Title			
RS-485 half duplex			
Size A	Document Number <Doc>		Rev <RevCode>
Date:	Friday, December 11, 2020		Sheet 4 of 4

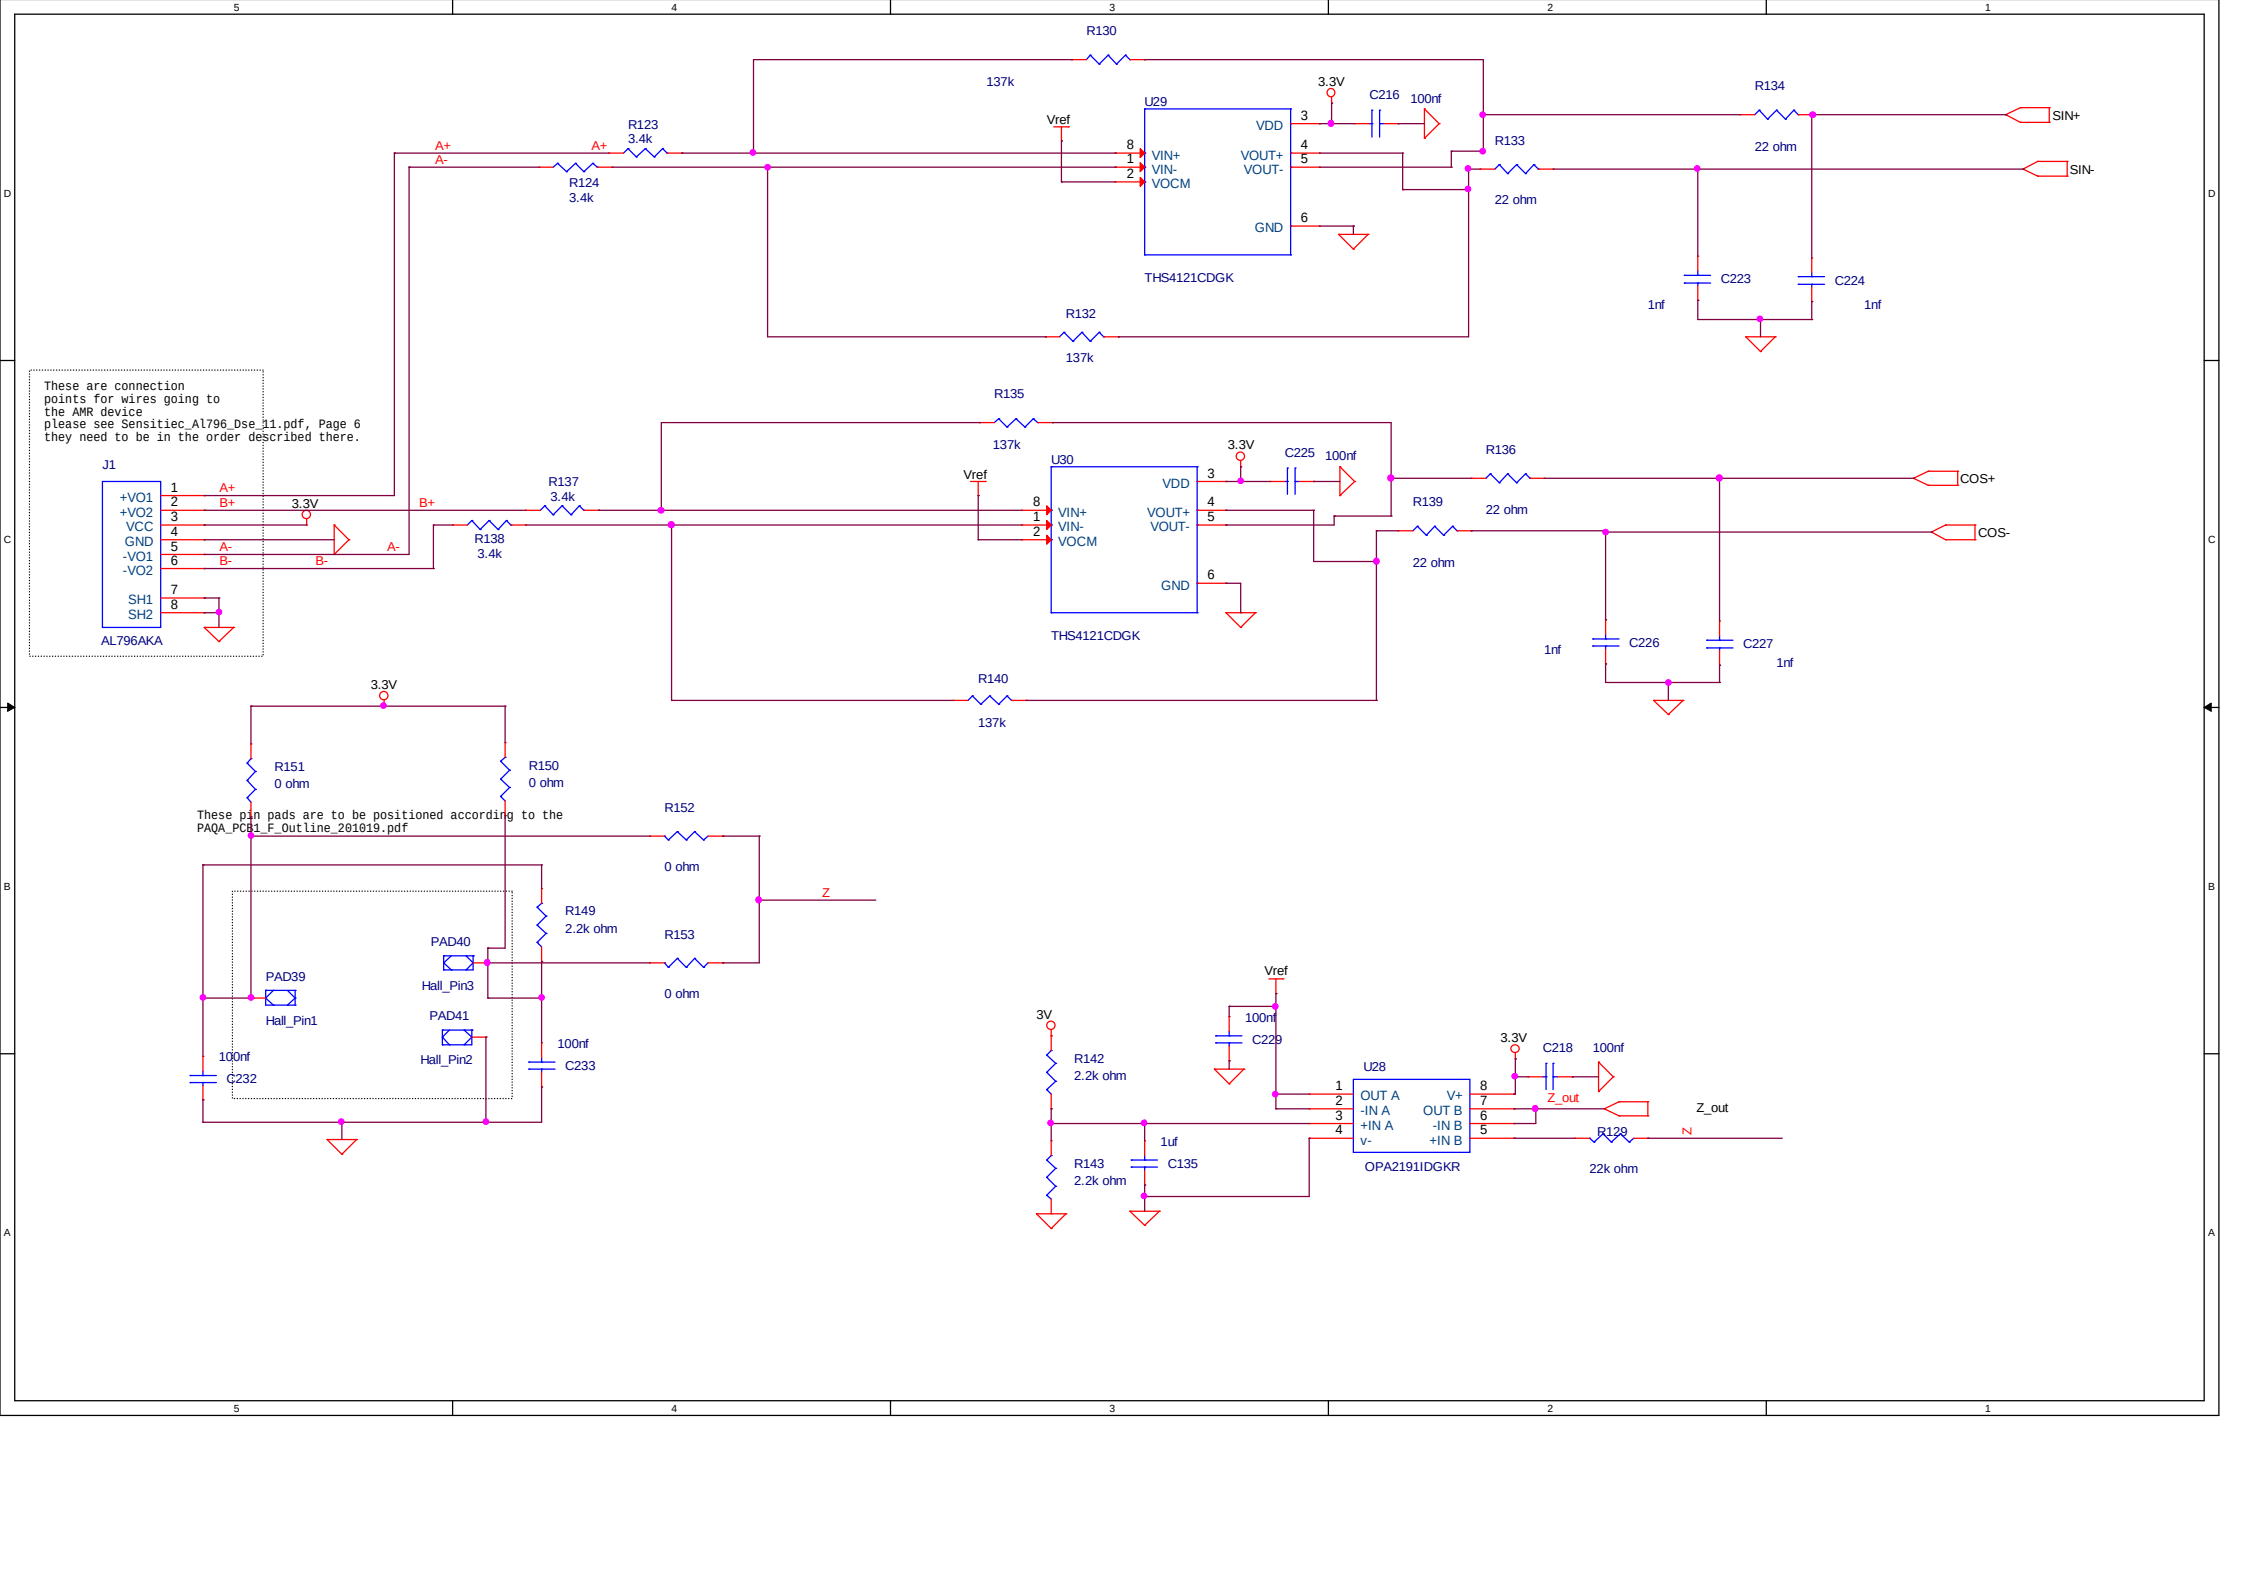
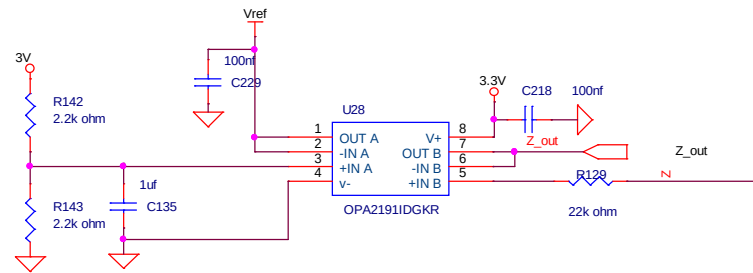
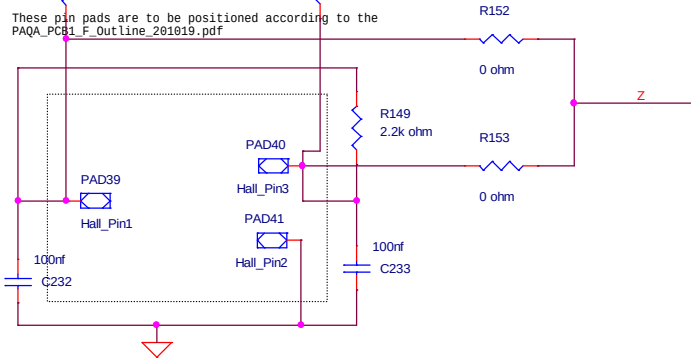
These are connection points for wires going to the AMR device please see Sensitiec_AL796_Dse_11.pdf, Page 6 they need to be in the order described there.

These pin pads are to be positioned according to the PAQA_PC81_F_outline_201019.pdf

Title		<Title>	
Size	Document Number		Rev
	<Doc>		
Date:		Friday, December 11, 2020	Sheet 3 of 4
1

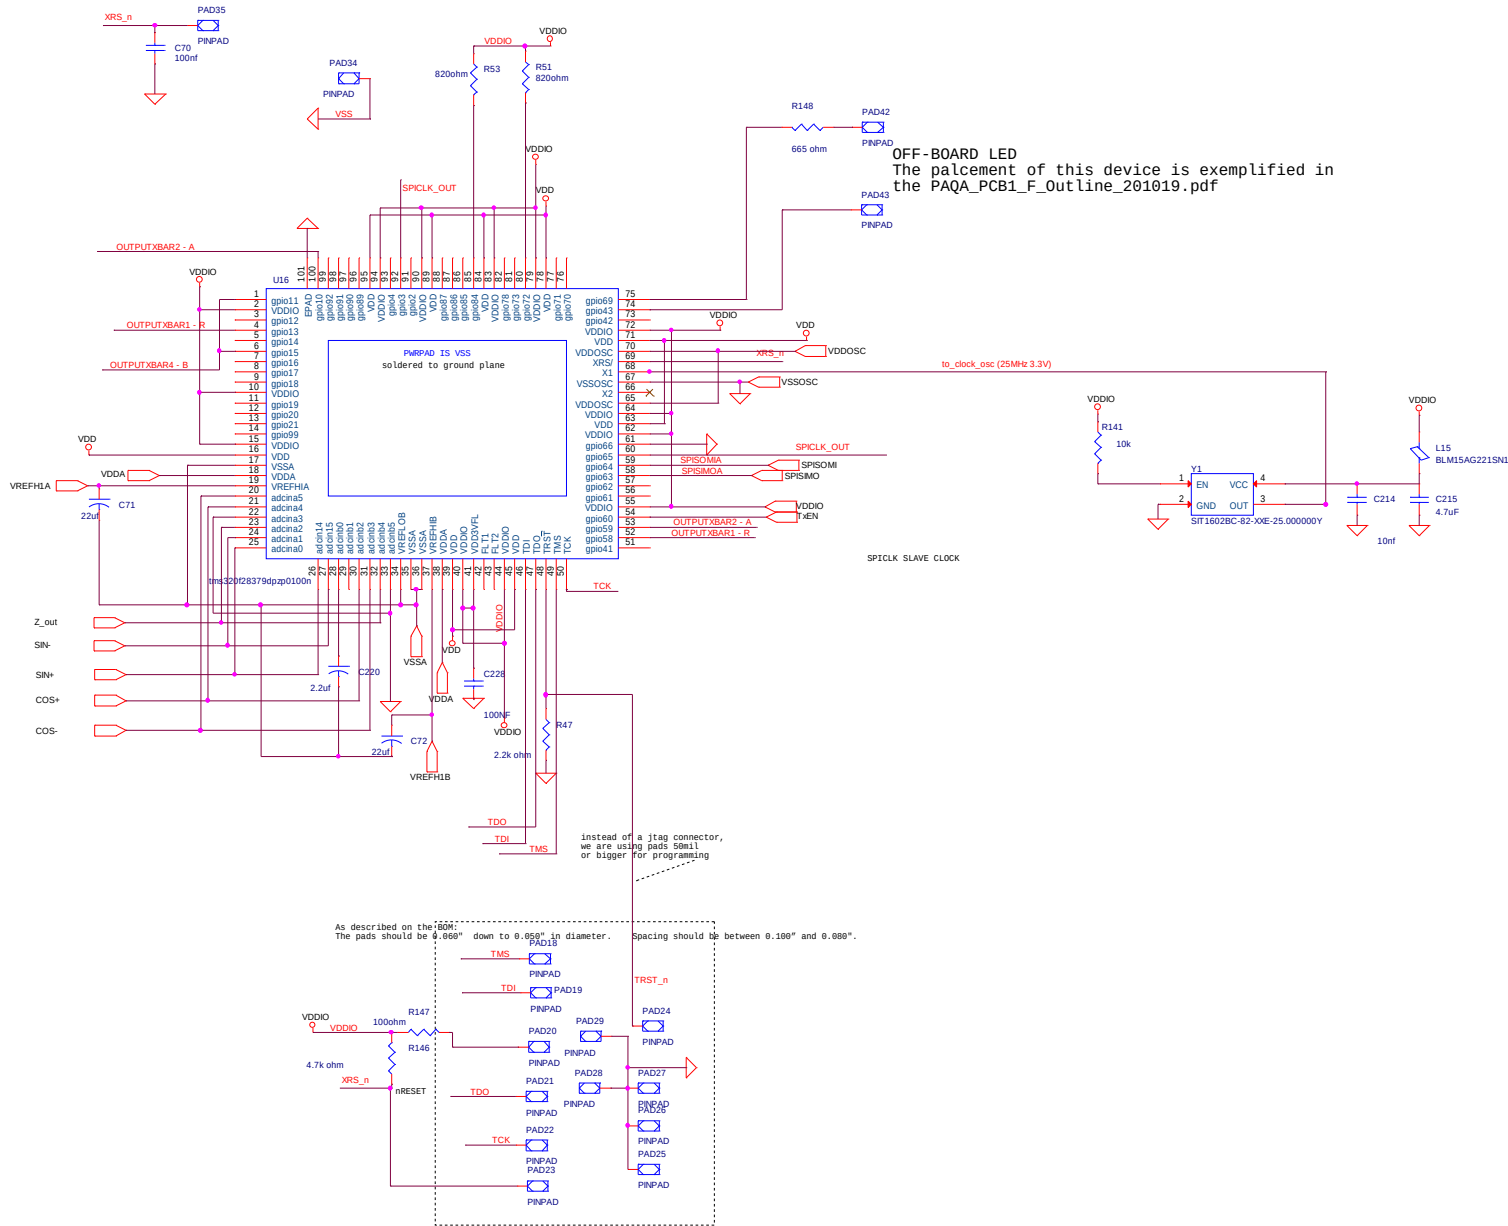
As described on the BOM:
The pads should be 0.060" down to 0.050" in diameter. Spacing should be between 0.100" and 0.080".

OFF-BOARD LED
The placement of this device is exemplified in the PAQA_PCB1_F_Outline_201019.pdf

Instead of a jtag connector, we are using pads 58m11 or bigger for programming

As described on the BOM:
The pads should be 0.060" down to 0.050" in diameter. Spacing should be between 0.100" and 0.080".

this should be the connection scheme for the 25MHz clock. I thought you might want to choose the part for the layout.

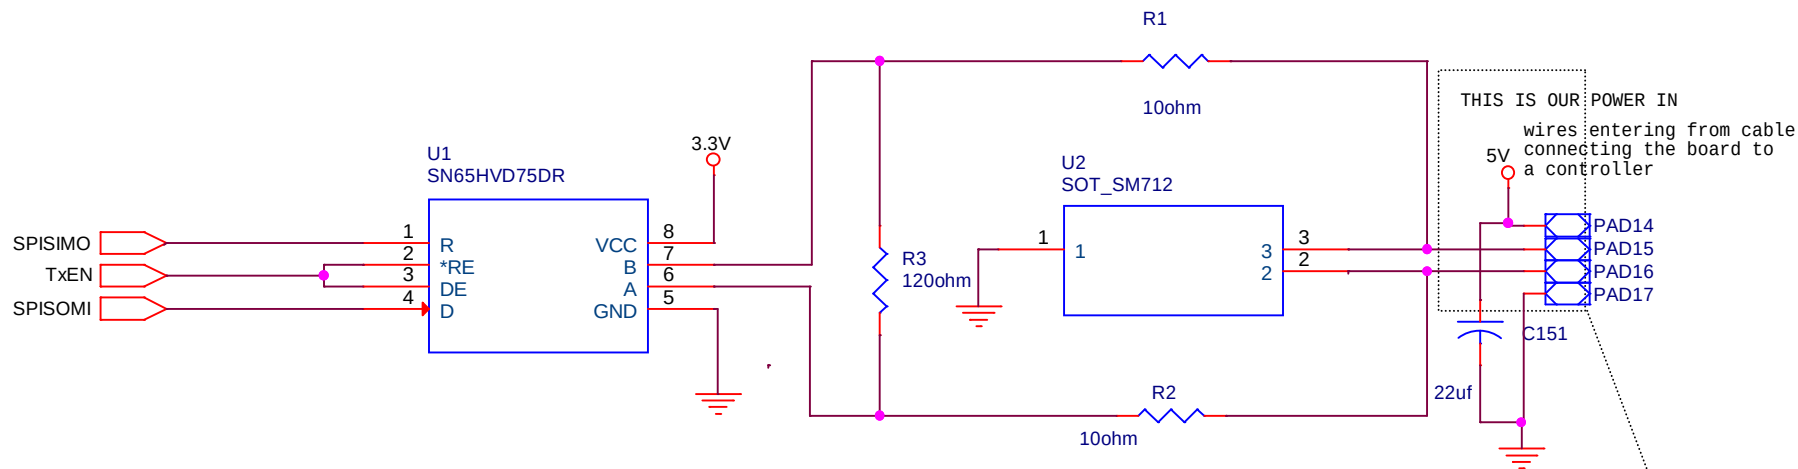
These pads should be large enough to allow us to solder a B4B-EH-A(LF)(SN), the spacing and pin sizing is adequate JST Sales America Inc., Digikey # 455-1613-ND We will not actually be using the part, just offering it for sizing purposes
